Land to the south of HSDC, Waterloooville

Stage 1 Road Safety Audit : Designer's Response

Project No.	1017
Revision	Initial Issue
Date	21 st March 2022
Client	Places for People
Prepared	B Fenton
Checked	C Grindle
Authorised	A Wozniczko
File Ref.	P:\1017 South Downs College\C Documents\Reports\RSA Designer's Response

DRAWINGS SHOWING LOCATIONS OF PROBLEMS IDENTIFIED

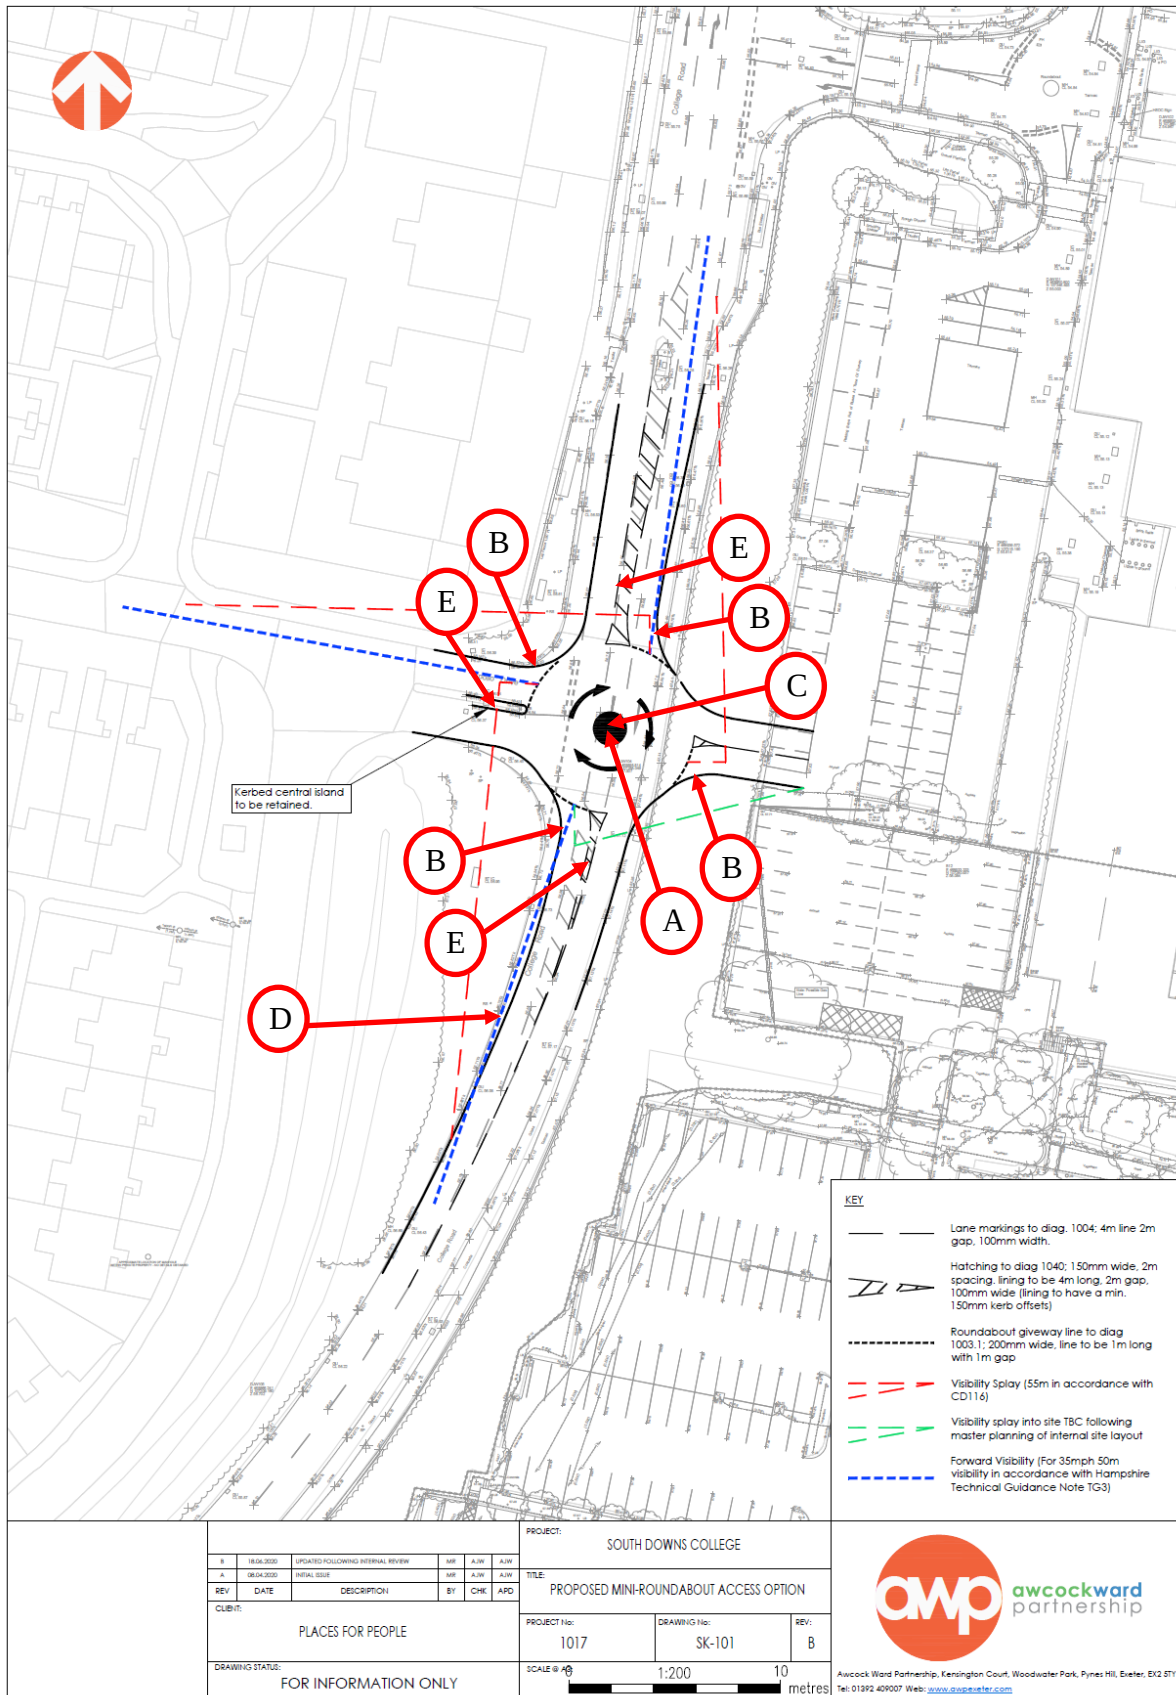
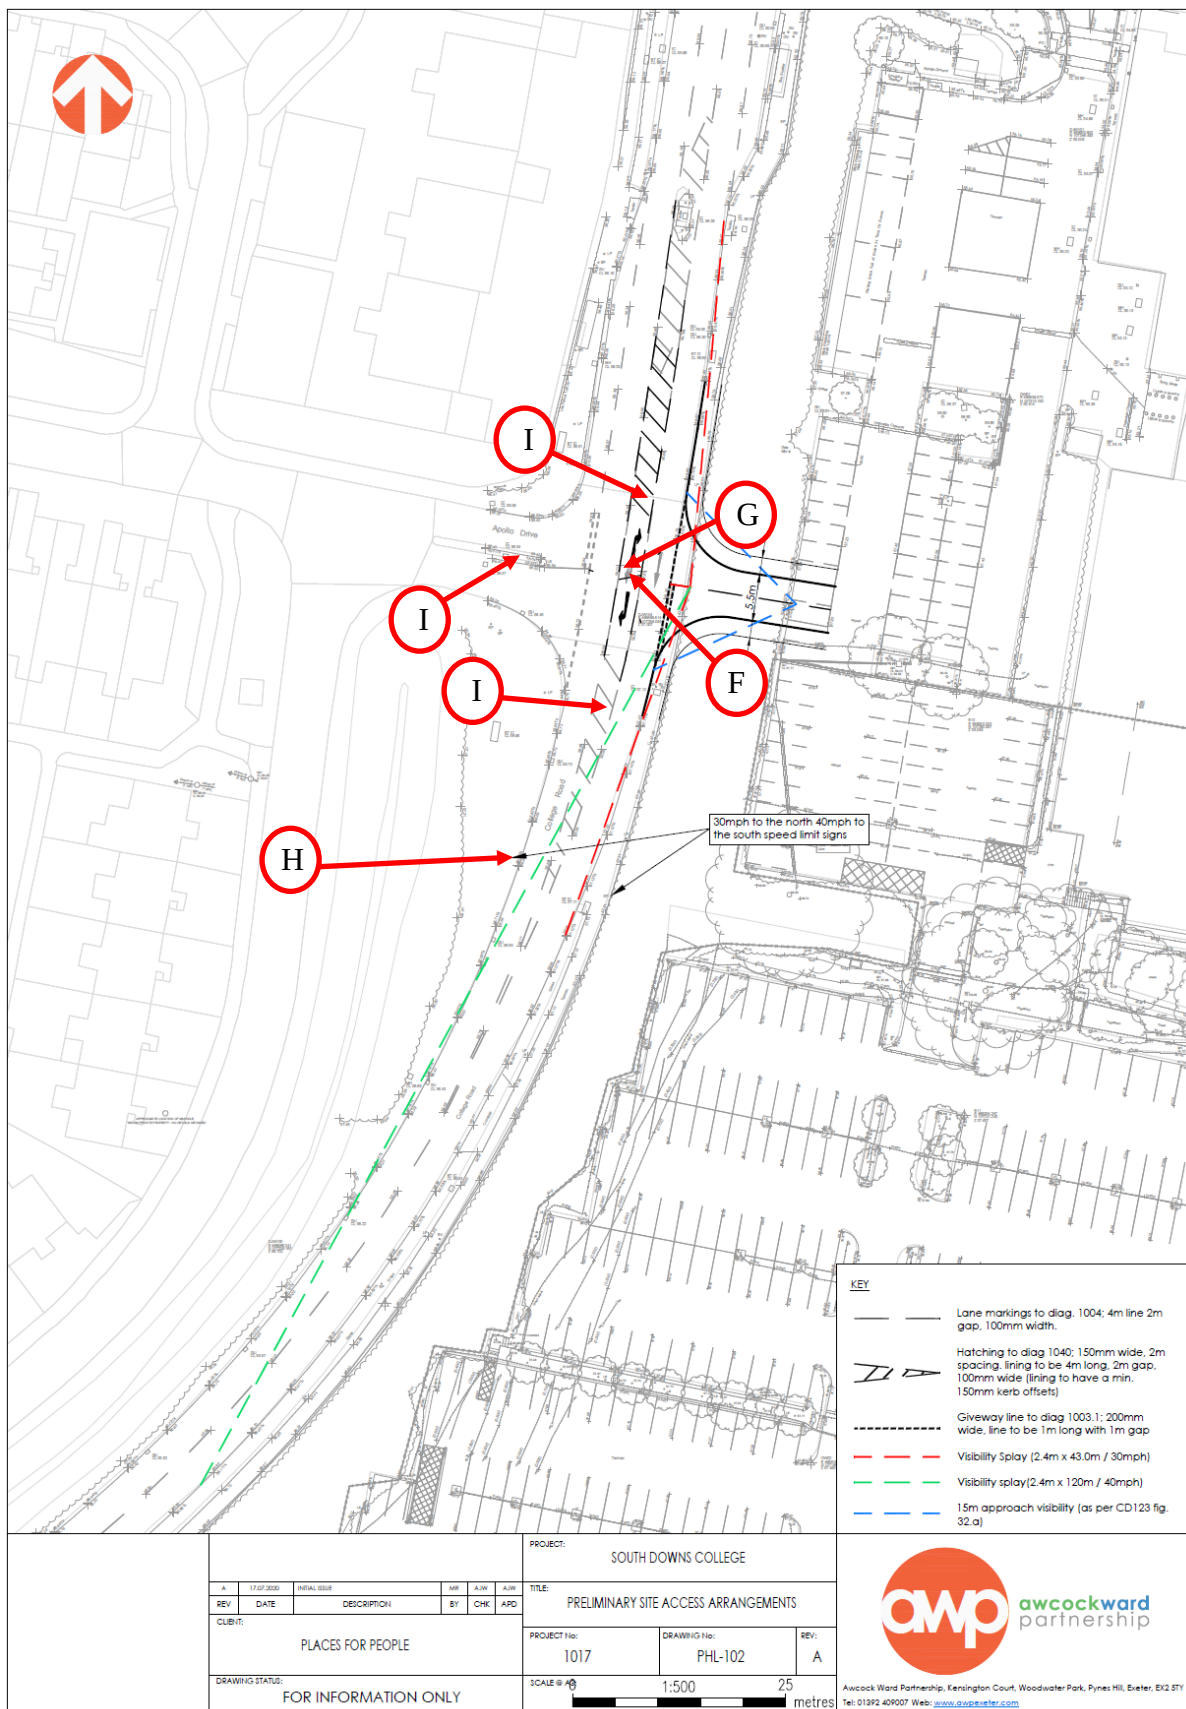
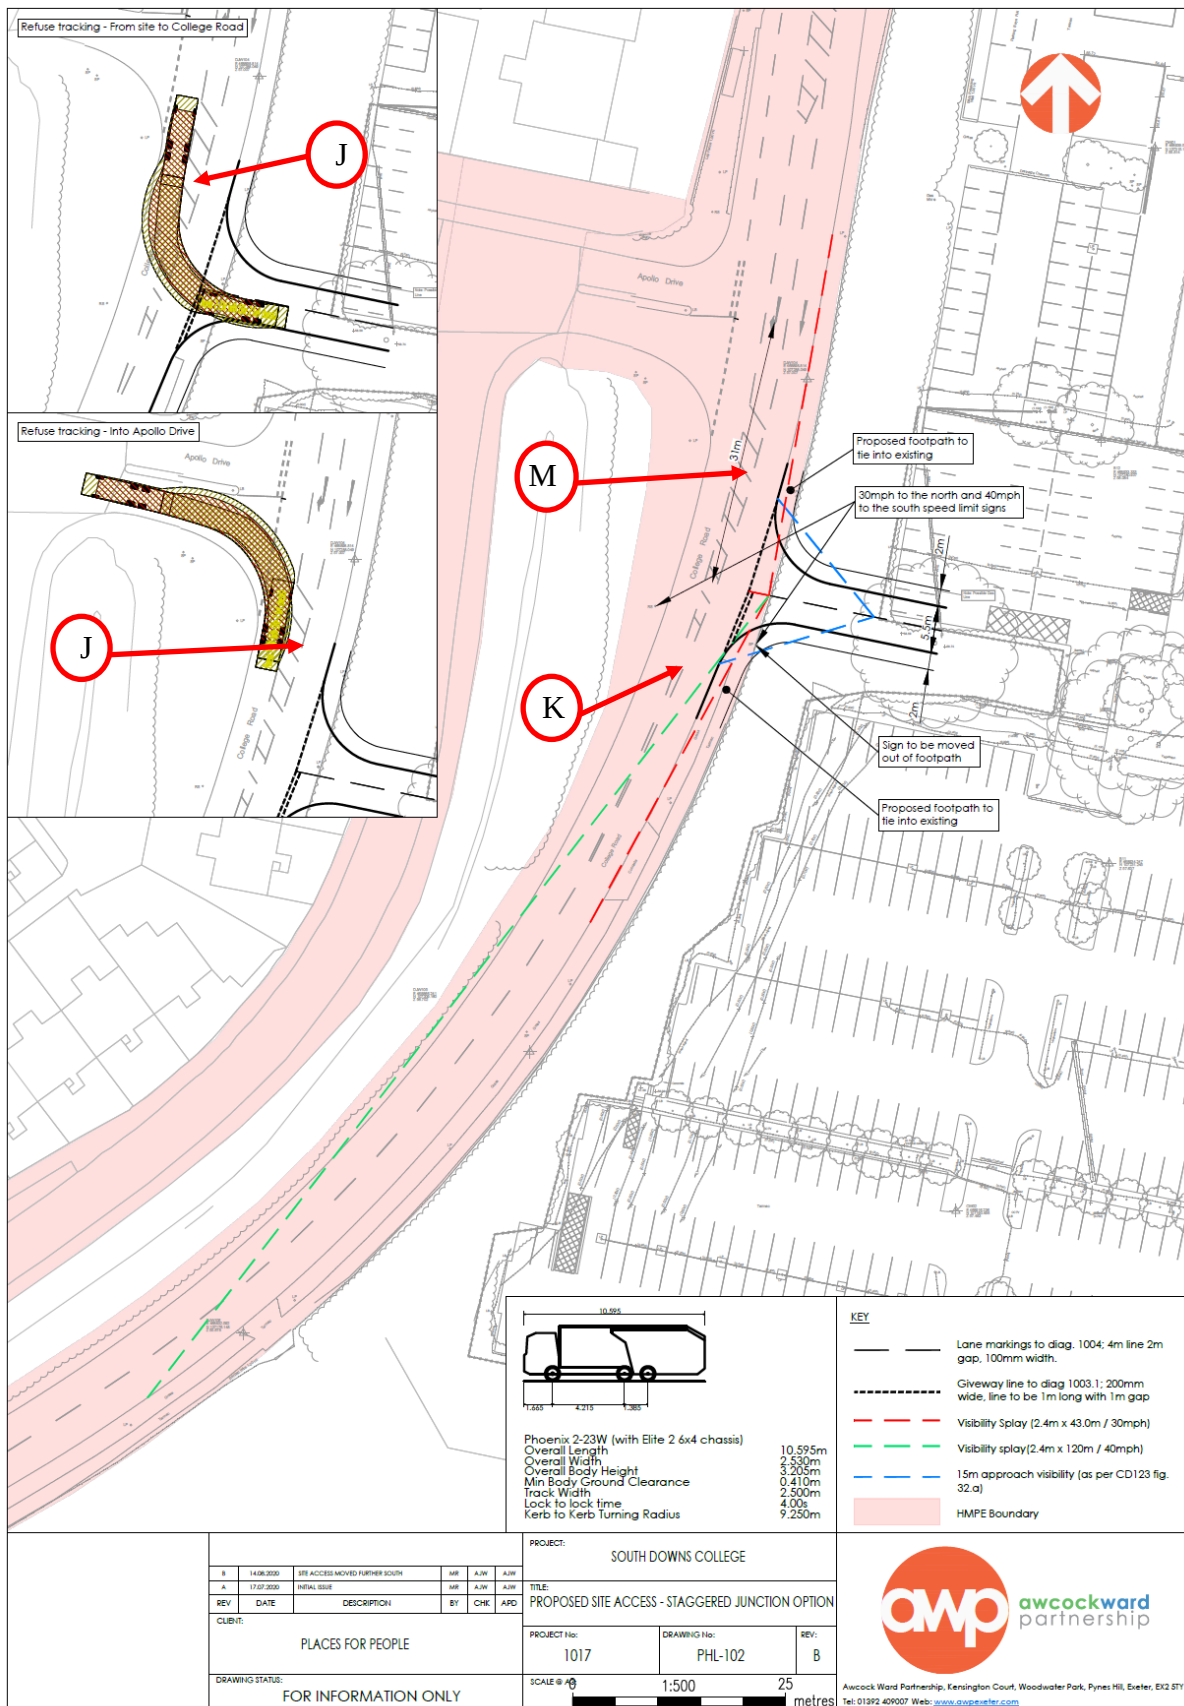
Whilst the Audit team note the content of the Pre-Application Scoping Note – (Access & Transport) with regard to traffic capacity at the proposed new four arm mini roundabout they remain concerned that when considering the proposed new traffic signal junction at the nearby Camptown development immediately southwest of the proposed mini roundabout that this could result in significant traffic congestion. In particular, four arm mini roundabouts will have four crossovers giving significant opportunity for collisions to take place during a busy peak hour period. Additionally, mini roundabouts are of particular concern to riders of two wheeled vehicles who are over represented in collisions at mini roundabouts and normal roundabouts alike.

If the four-arm mini roundabout option proceeds then the Audit team would recommend that the design as presented is revisited to look at the potential for two lane approaches in order to separate ahead and right turning traffic. Additionally, if feasible a separate access to the development should be provided for cyclists and pedestrians.

The Audit team are concerned that the proposed four arm mini roundabout design lacks adequate entry deflection, particularly on the northeast and southwest approaches on College Road. Inadequate entry deflection on the approach to a mini roundabout could lead to an inappropriate approach speeds, overshoots and side impact type collisions.

Notwithstanding recommendation 3.1 above the design as presented should be revisited to allow for adequate entry deflection on all approaches to the mini roundabout, but in particular for those on College Road.

The Audit team are concerned that the drawing provided for the proposed four arm mini roundabout does not provide for the swept path analysis of the largest vehicle likely to need to negotiate the junction from all arms. Insufficient road space for the largest vehicle required to negotiate the proposed new mini roundabout junction could lead to sideswipe type collisions, injudicious reversing, shunts and the potential for over running of the footway and collisions with pedestrians and passing cyclists.

The design of the proposed four arm mini roundabout should provide for sufficient road space to accommodate the largest vehicle required to use the junction from all directions.

The Audit team are concerned that the current location of the start of the 30mph speed limit on College Road is too close to the proposed new four arm mini roundabout junction. This could lead to inappropriate approach speeds on College Road which in turn could lead to heavy braking, shunts, overshoots and side impact type collisions on the proposed new mini roundabout.

The existing 30/40 mph speed limit interface should be relocated an appropriate distance, south-westwards on College Road to allow drivers approaching the new four arm mini roundabout to reduce their speed sufficiently in anticipation of the potential need to give way.

It is not clear from the drawing what if any facilities for pedestrians will be provided to cross College Road and Apollo Drive at the proposed new four arm mini roundabout junction. Inadequate facilities for pedestrians to cross College Road and Apollo Drive to and from the new development could lead to potential slips and trips, particularly involving pedestrians with visual or physical impairments and parents with buggies.

The proposed four arm mini roundabout junction should provide adequate provision for crossing pedestrians.

The drawing indicates a confusing road layout for drivers and riders wishing to turn right into the new development or into Apollo Drive as it requires right turning drivers / riders to pass one another before they turn right which is unlikely to take place. This could lead to drivers attempting to turn right in the opposing right turn pocket which in turn could lead to side impact and head on type collisions. Additionally, at peak periods it is unlikely that the design as presented would have adequate stacking capacity to accommodate right turning drivers and riders into either Apollo Drive or the new development. As such, this could lead to tailbacks, shunts, side impact and sideswipe type collisions with following vehicles. Furthermore, the right turn pocket into the proposed development will lead drivers and riders into a full height kerb where they could mount the pavement with the potential to collide with passing pedestrians.

The design as presented should be revisited with a view to investigating the potential for a ghost island right turn lane for right turning traffic in both directions on College Road.

The Audit team are concerned that the drawing provided for the proposed cross roads does not provide for the swept path analysis of the largest vehicle likely to need to negotiate the junction from all arms. Insufficient road space for the largest vehicle required to negotiate the proposed new crossroads layout could lead to sideswipe type collisions, injudicious reversing, shunts and the potential for over running of the footway and collisions with pedestrians and passing cyclists.

The design of the proposed new cross roads layout should provide for sufficient road space to accommodate the largest vehicle required to use the junction from all directions.

The Audit team are concerned that the current location of the start of the 30mph speed limit on College Road is too close to the proposed new cross roads layout, particularly considering right turning drivers and riders will need to slow down to turn right into the right turn pocket for the new development. This could lead to inappropriate approach speeds on College Road which in turn could lead to heavy braking, shunts, injudicious reversing and side impact type collisions.

The existing 30/40 mph speed limit interface should be relocated an appropriate distance, south-westwards on College Road to allow drivers approaching the new right turn bay to reduce their speed sufficiently in order to turn right.

It is not clear from the drawing what if any facilities for pedestrians will be provided to cross College Road and Apollo Drive at the proposed new cross roads layout. Inadequate facilities for pedestrians to cross College Road and Apollo Drive to and from the new development could lead to potential slips and trips, particularly involving pedestrians with visual or physical impairments and parents with buggies.

The proposed new cross roads layout should provide adequate provision for crossing pedestrians.

The drawing shows the swept path of a standard refuse collection vehicle turning left into Apollo Drive and right from the proposed new site access road. However, there is no swept path indicated for the other manoeuvres into and out of the remaining arms of the staggered junction, in particular a large right turning vehicle from Apollo Drive into College Road. As such, the Audit team are concerned that such a manoeuvre could lead to a head on collision with a similar vehicle turning right from the new site access simultaneously. Additionally, injudicious manoeuvres could be caused including reversing, mounting of the verge and mounting of the footway with the potential for collisions with passing pedestrians.

The design of the proposed new staggered junction layout should provide for sufficient road space to accommodate the largest vehicle required to use the junction from all directions.

The Audit team are concerned that the proposed staggered junction layout as presented on the drawing does not provide for any stacking capacity during peak periods. This could lead to tailbacks, driver frustration and injudicious manoeuvres including mounting of the footway which in turn could lead to collisions with passing pedestrians.

The design as presented should be revisited with a view to investigating the potential for a ghost island right turn lane for right turning traffic in both directions on College Road.

The Audit team are concerned that the current location of the start of the 30mph speed limit on College Road is too close to the proposed new staggered junction layout, particularly considering right turning drivers and riders will need to slow down to turn right into the new development. This could lead to inappropriate approach speeds on College Road which in turn could lead to heavy braking, shunts, injudicious reversing and side impact type collisions.

The existing 30/40 mph speed limit interface should be relocated an appropriate distance, south-westwards on College Road to allow drivers approaching the new staggered junction to reduce their speed sufficiently in order to turn right.

It is not clear from the drawing what if any facilities for pedestrians will be provided to cross College Road and Apollo Drive at the proposed new staggered junction layout. Inadequate facilities for pedestrians to cross College Road and Apollo drive to and from the new development could lead to potential slips and trips, particularly involving pedestrians with visual or physical impairments and parents with buggies.

The proposed new staggered junction layout should provide adequate provision for crossing pedestrians.
